TECHNICAL BULLETIN INDEX
Sorted by Bulletin Number
04/03/86

BULLETIN NO: II:1

PRODUCT: 26-4001/2 Model II

Figure 1

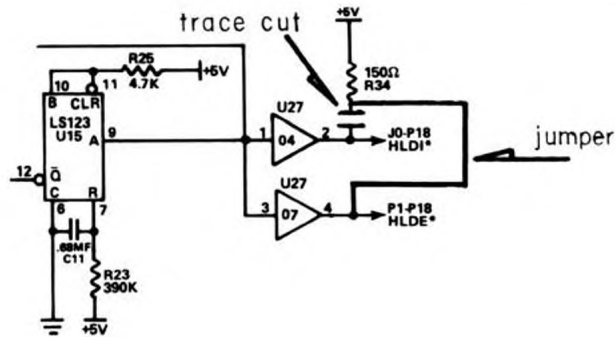
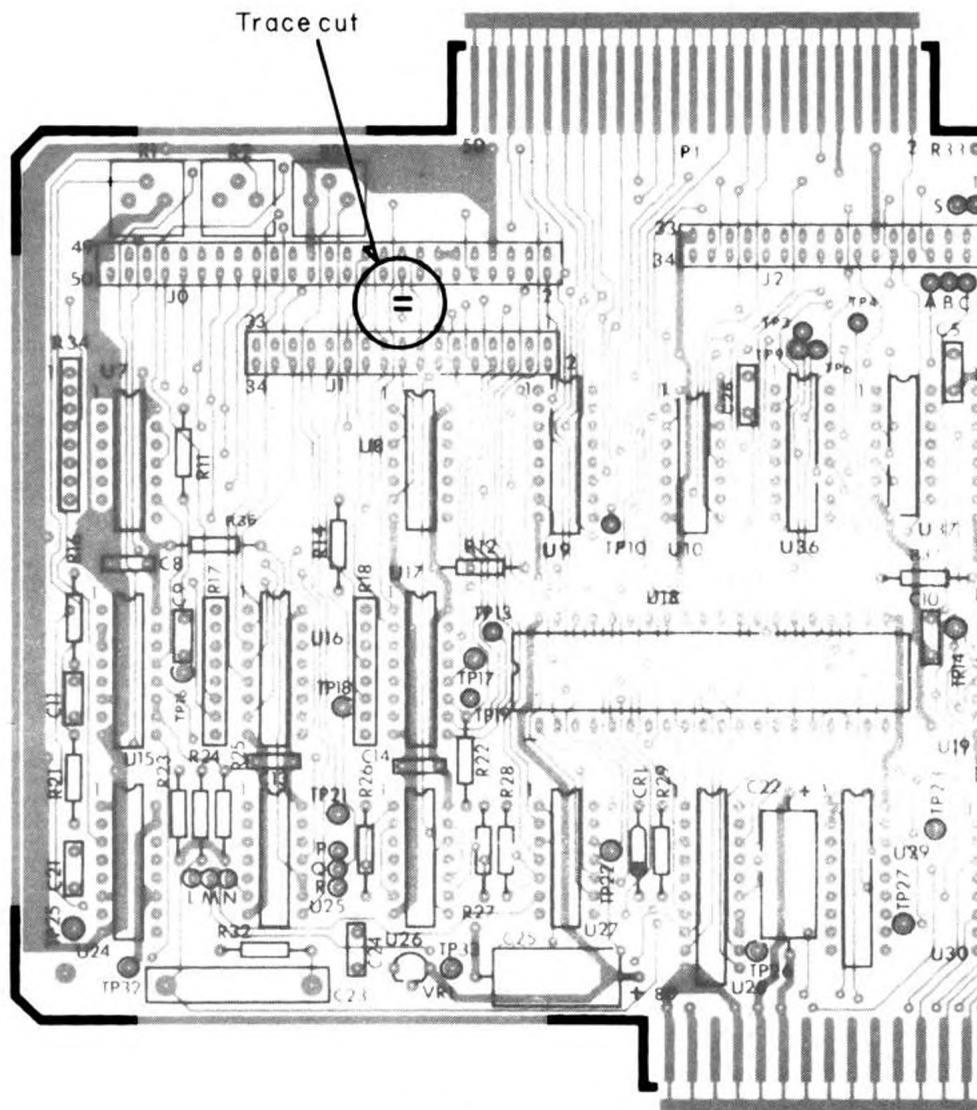
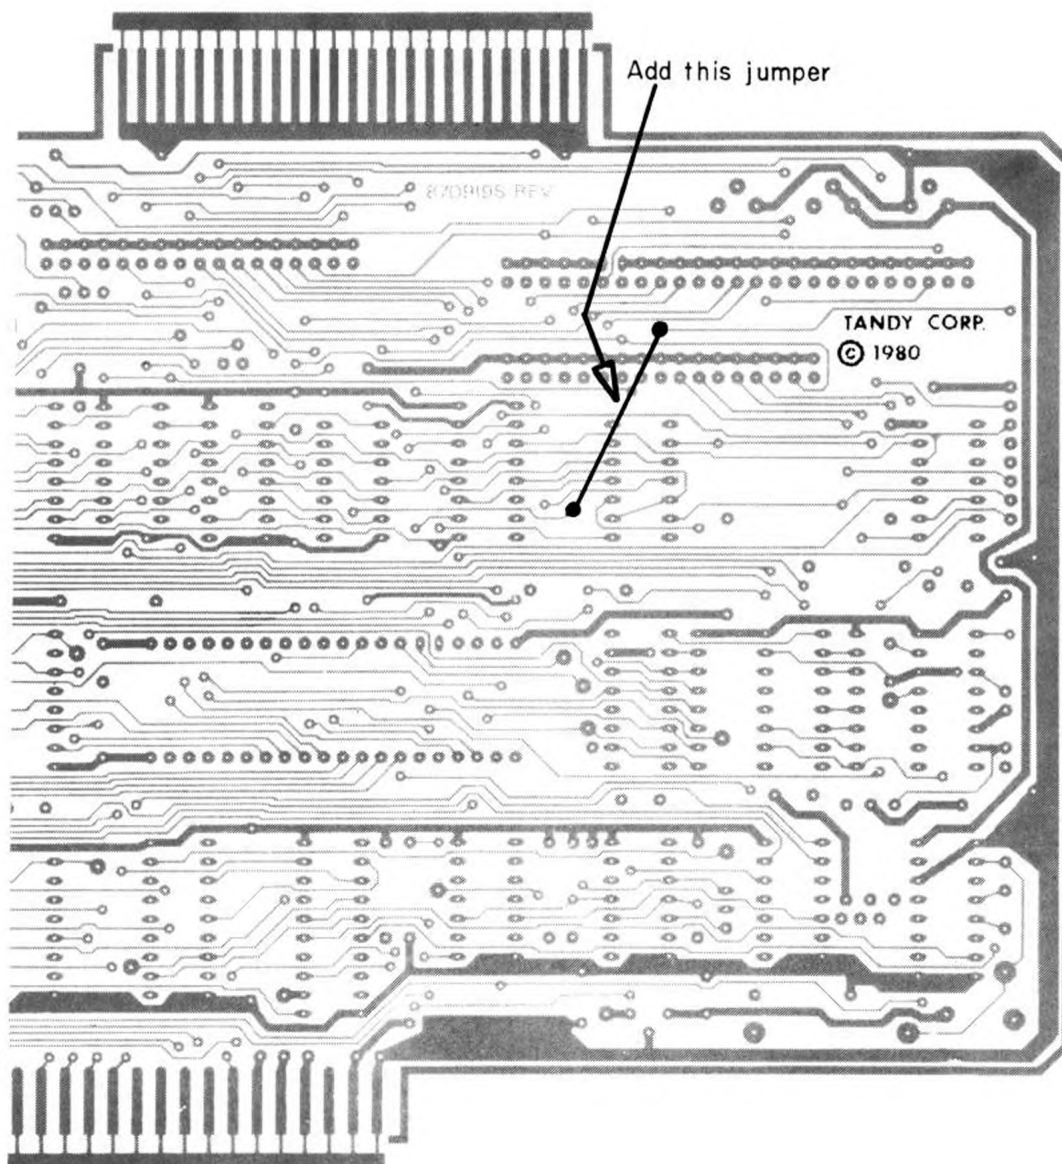
PURPOSE: To correct Head Load termination on FDC board (Late design/Rev Blank).

DISCUSSION: On the redesigned FDC board (Rev Blank) there is a pullup resistor on the Head Load signal for internal drives, but there is none for external drives. With the Model II the internal drive has Head Load termination on the board but the bay does not. With the FDC board (Redesign) this means that the internal drive has double Head Load termination while the external Head Load signal has no pullup. To correct this problem we eliminate the internal Head Load signal on the FDC board and use its pullup for the external Head Load signal (Refer to Figure 1).

1. On the componet side, cut the trace that goes to pin 18 of J0 (the 50 position pin header connector) RIGHT AT the connector so that the feedthru can still be used on the reverse side to go to the external head load signal (Refer to Figure 2).
2. Turn the board over to the solder side and solder a jumper from the feedthru referenced in step 1 (this is the pullup resistor line) to the feedthru between U8 and U9 that is closest to pin 8 and 9 of U8. This feedthru is the Head Load external signal external signal and goes over to U10 on the solder side of the board (Refer to Figure 3).

Figure 1

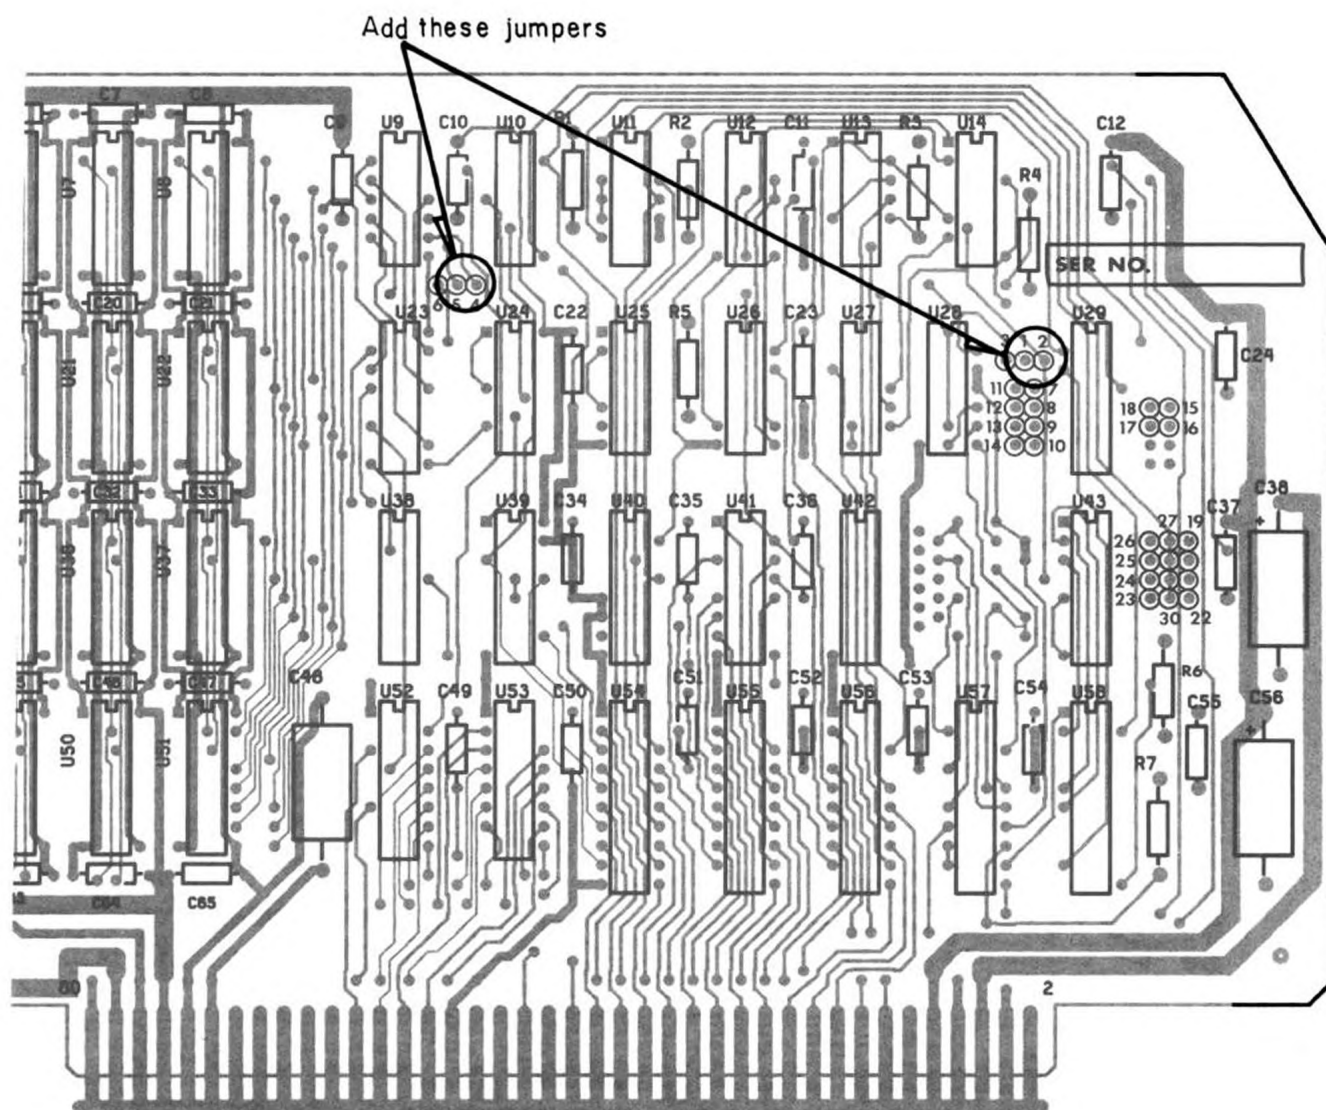
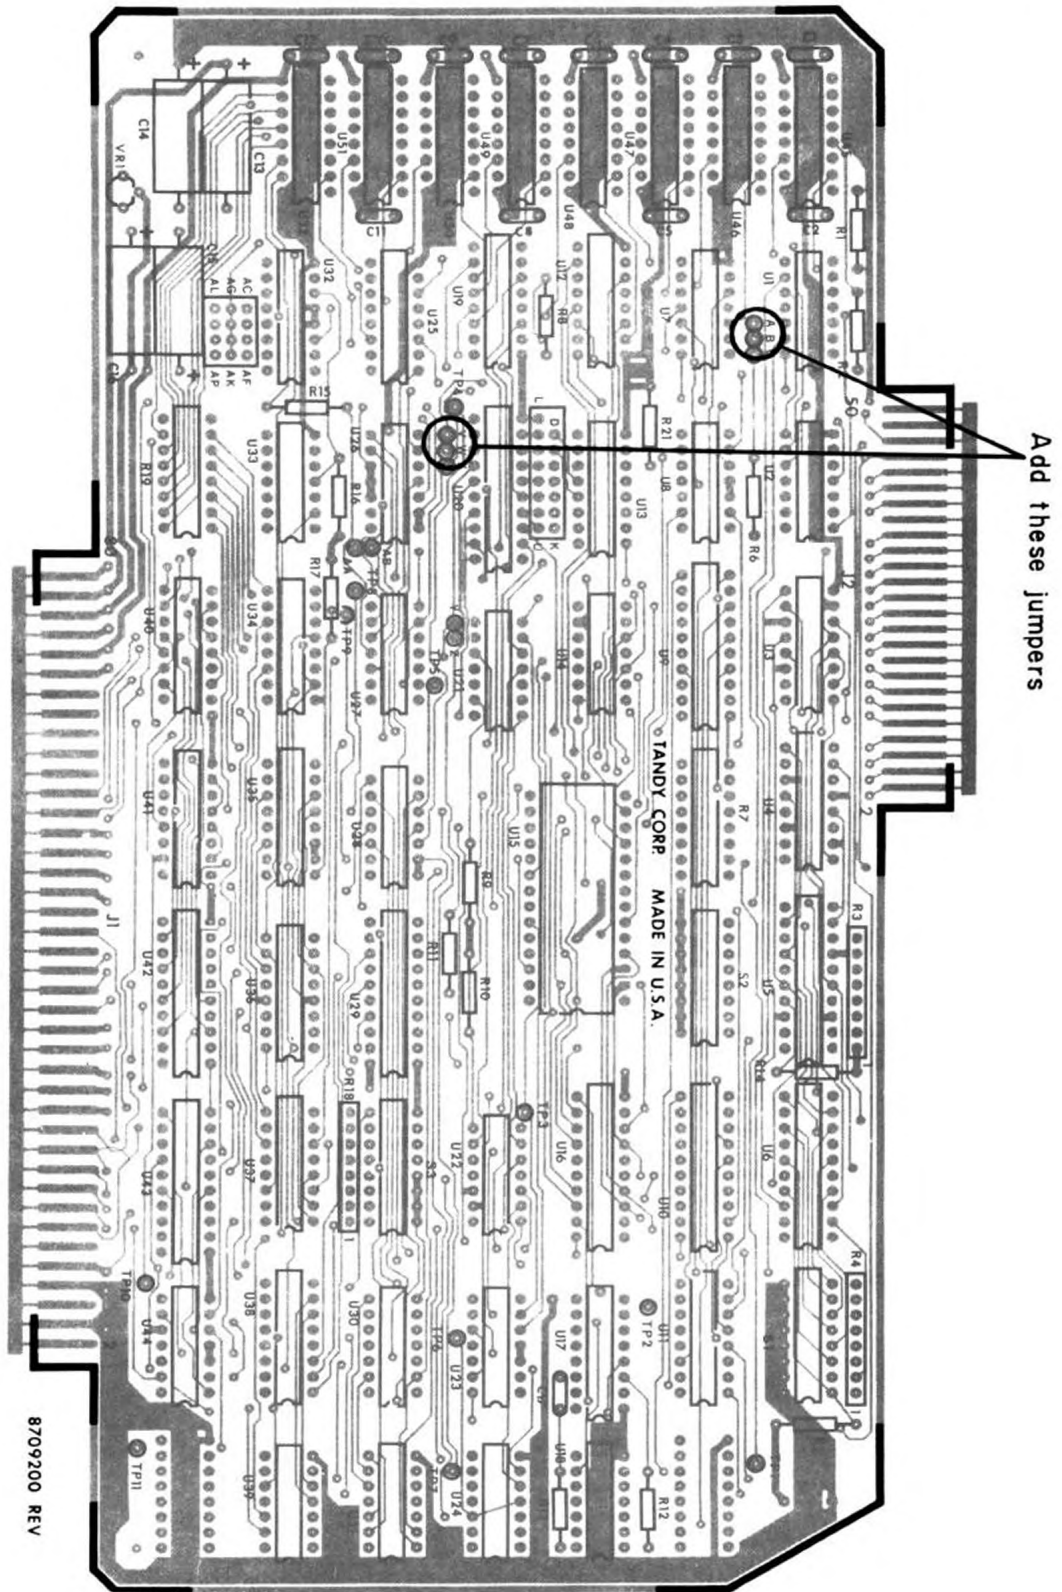
DISCUSSION: Pullups are needed on memory boards for inputs to gates. Intermittent problems can occur without these pullups installed. Some of the Model II memory boards may be missing staking pins for push on connectors and appropriate markings. In this case, use wirewrap to jumper the pads and refer to Figure 1 for pad locations.

PROCEDURE: Check boards for proper jumpering and install jumpers if they are missing. For physical locations of jumpering positions refer to Figure 1 for the memory board and Figure 2 for the Interface board.

Hard Disk Interface:
Jumper A-B and W-V

Model II Memory boards:
Jumper 1-2 and 5-6

Figure 1.

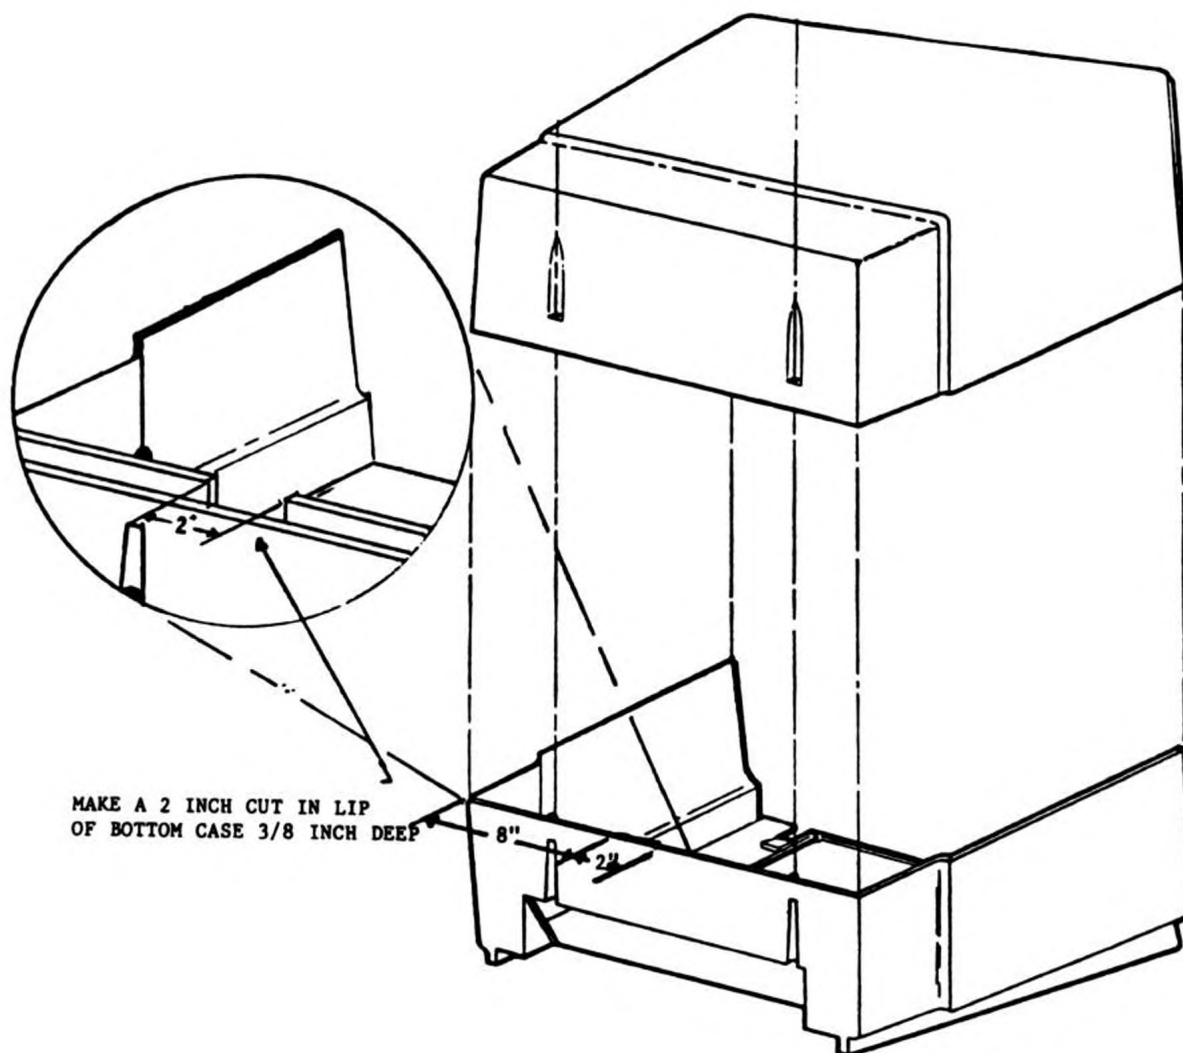
1. Remove case top to allow access to the case bottom.
2. (Refer to figure 1.) Measure 8" inches from left side (drive side) make a 3/8" inch deep cut, then measure 2" inches from first cut, and make another 3/8" inch deep cut. Cut away the two inches of plastic between the cuts. Clean the notch and make it smooth as possible.
3. Install Multi-terminal Interface board in #4 slot of card cage (count from the Z-80 CPU board to the left.) The proper slot positions should be filled as follows: (1) Z-80 CPU Board (2) FDC Board (3) Hard Drive Interface Board (4) Multi-terminal Interface Board (5) Video Board (6) 64K Memory Board (7) 68000 CPU Board (8) 16-Bit Memory Board, reading from right to left as you are facing the rear of unit looking at the card cage. If there is a board in #4 slot move all boards to the left leaving the #4 slot open for the multi-terminal board.
